ANNUNCIATOR RESPONSE

AR-971

CRYSTAL RIVER UNIT 3

CXAR ANNUNCIATOR RESPONSE

CONDENSATE POLISHING ANNUNCIATOR RESPONSE	CX-2-4
---	--------

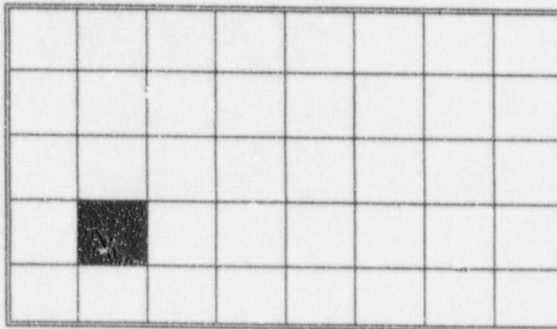
Changed Indicated Condition from '<1.25 PSI' to '> 1.23 PSID', per CX-118 thru CX-123-FS Instrument Data Sheets
Changed Redundant Indication from 'Light on' to 'Light out', per CX-118 thru CX-123-FS Instrument Data Sheets

- o DIFFERENTIAL PRESSURE ACROSS DEMINERALIZER 3A, B, C, D, E, OR F, RUPTURE DISK AS SEEN BY CX-118, 119, 120, 121, 122, OR 123-FS IS > 1.25 PSID

- o LOCAL AMBER LIGHT OUT AT THE CX PANEL AT 119' ELEVATION
